SVE BULLETIN

QVM Bulletin: Q-178

F53/ F59(2011) OBDII Diagnostic Connector Location

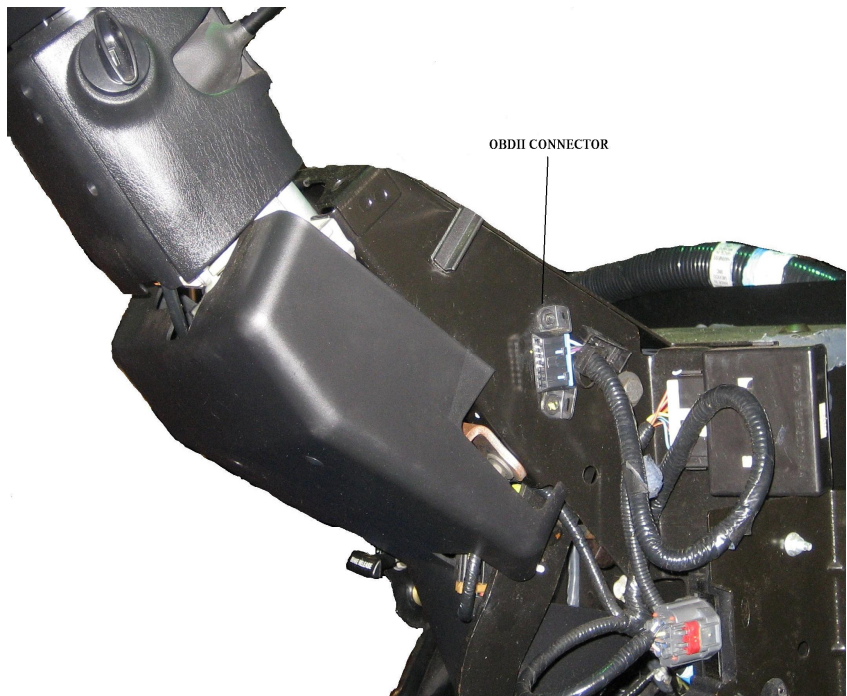
The OBDII diagnostic service port connector is attached to the right hand side of the steering column support during chassis assembly. This is intended to be a "temporary shipping location". It is the responsibility of the body builder to relocate the OBDII diagnostic connector to the bottom of the dash panel (not supplied by Ford).

Per SAE J1962 and ISO 15031-3, the OBDII diagnostic connector preferred location is under the dash panel, under the steering, +/- 150mm (i.e., +/- 6 inches on either side of the steering column).
